STAFF REPORT: 10-14-2020 MEETING

APPLICATION NUMBER: 20-6884

ADDRESS: 1035 CLARK

SCOPE: REPLACE EXISTING WOOD WINDOWS WITH NEW WOOD WINDOWS

EXISTING SASH DETAILS

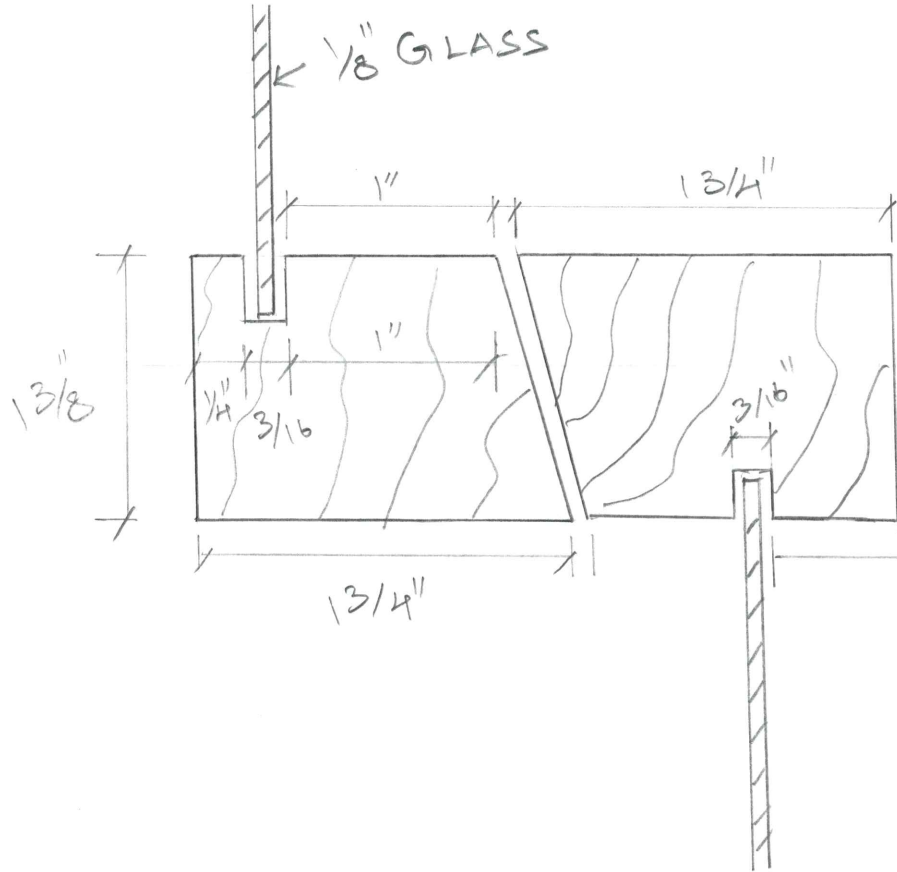
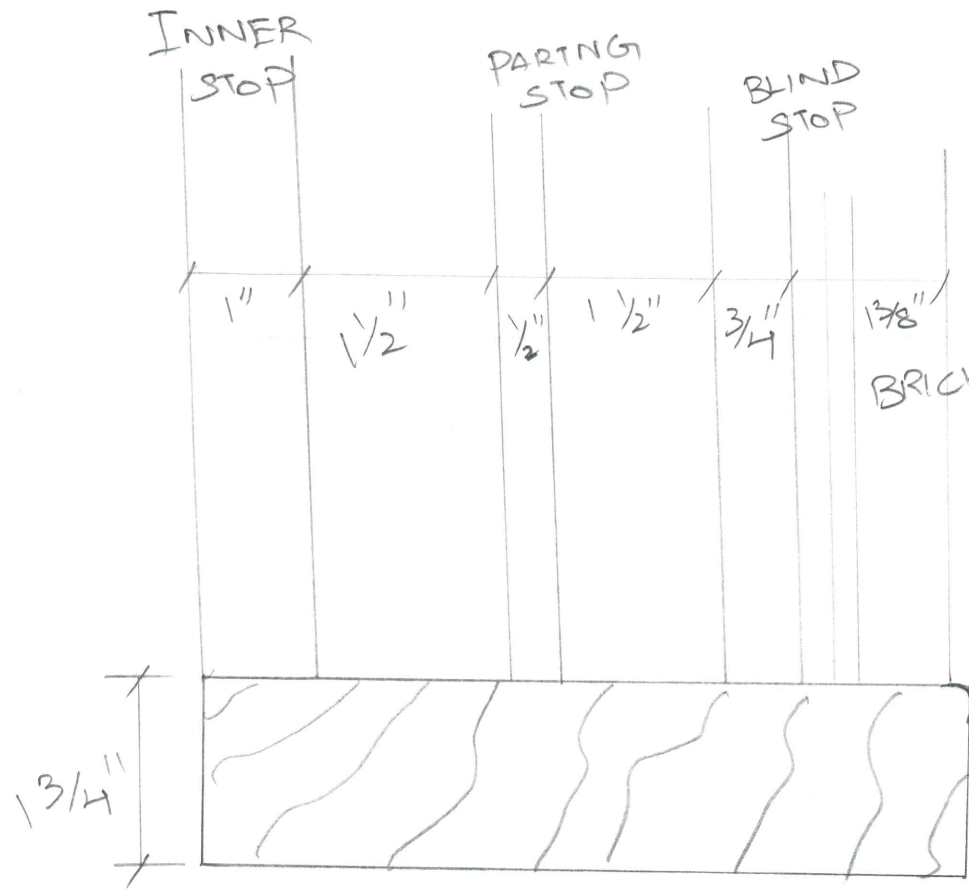
- The window replacement includes not just the operable sash but also the window jambs. The applicant confirmed with HDC staff the casings, inner stop, and brick mould will be retained and the windows will remain covered with aluminum trim.
- The applicant has not identified the exterior aluminum-cladding color.
- The proposed windows only offer between-the-glass muntins.
- The window order proposes to replace ALL of the windows in the house; the leaded glass transom will be removed and replaced with a clear glass transom.
- The applicant proposes to install Weather Shield Windows, Weather Shield series. These are wood-framed units with exterior aluminum cladding. The comparison of the existing wood frames against the Weather Shield window frames is below.

<u>Existing Frames</u>		<u>Proposed Frames</u>		<u>Percentage Increase</u>
Width of frame	2”	Width of frame	3-3/16”	62%
Depth of frame	1-3/8”	Depth of frame	4-9/16”	200%
Height of meeting rail	1-3/8”	Height of meeting rail	2-7/8”	100%
Depth of meeting rail	1-3/8”	Depth of meeting rail	3-3/16”	133%

- The existing windows will remain in place until the replacement windows are approved by Commission staff.
- The new window frame dimensions shall not increase more than ¼-inch (from the existing frame dimensions).
- The operation and glass within each new window unit will match the existing window.
- The leaded glass transom window will remain in place and be repaired as needed.
- Existing wood mullions, if present, will remain in place. New, single window units will be inserted into existing window openings.
- The casement windows will have a simulated divided light muntins pattern.
- The new windows will be solid wood (exterior to be painted) **or** solid wood, aluminum-clad units. The exterior frame color will be submitted for review.
- The existing exterior wood brick mould will be retained and will remain covered with aluminum.

WEATHER SHIELD DOUBLE HUNG WINDOW (610)
Vertical Section

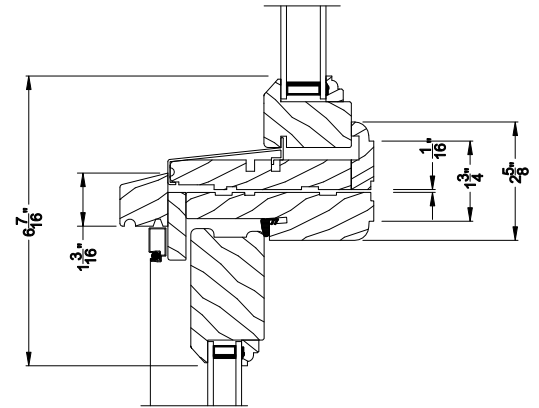
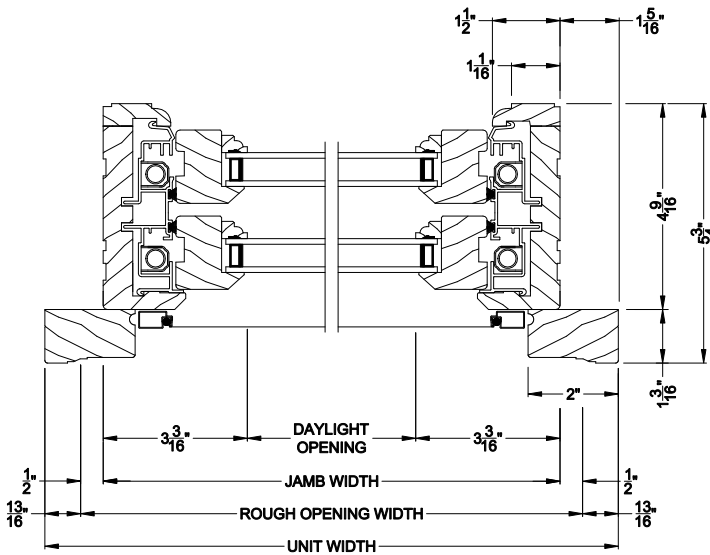
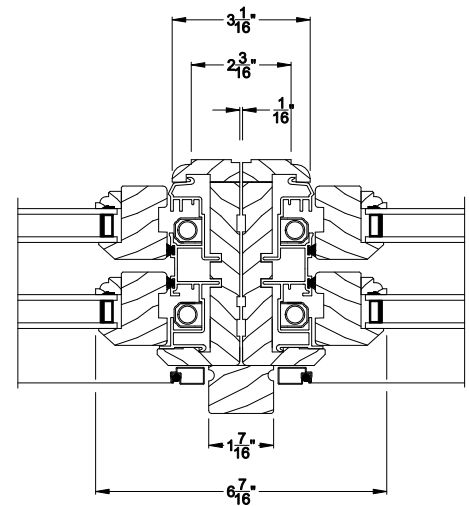
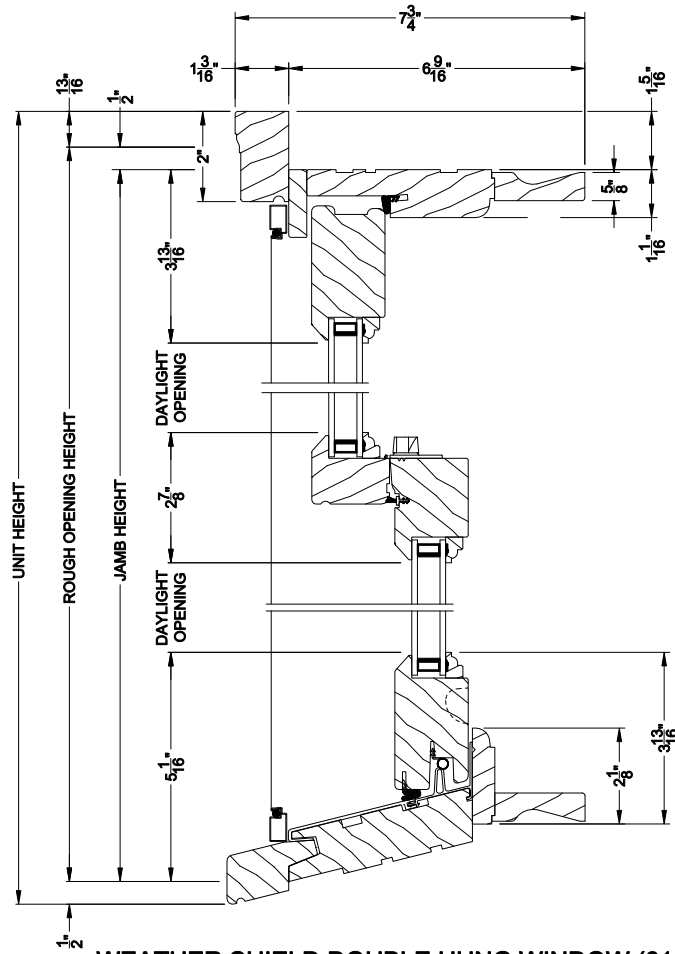
- The Weather Shield, wood aluminum-clad windows have substantially thicker window frames. The dimensional increase is too large, and the loss of the leaded glass transom and between-the-glass muntins are not compatible with the scale and architectural features of the existing windows and house. Therefore, it is staff’s opinion the proposed windows do not meet the Secretary of the Interior Standards.
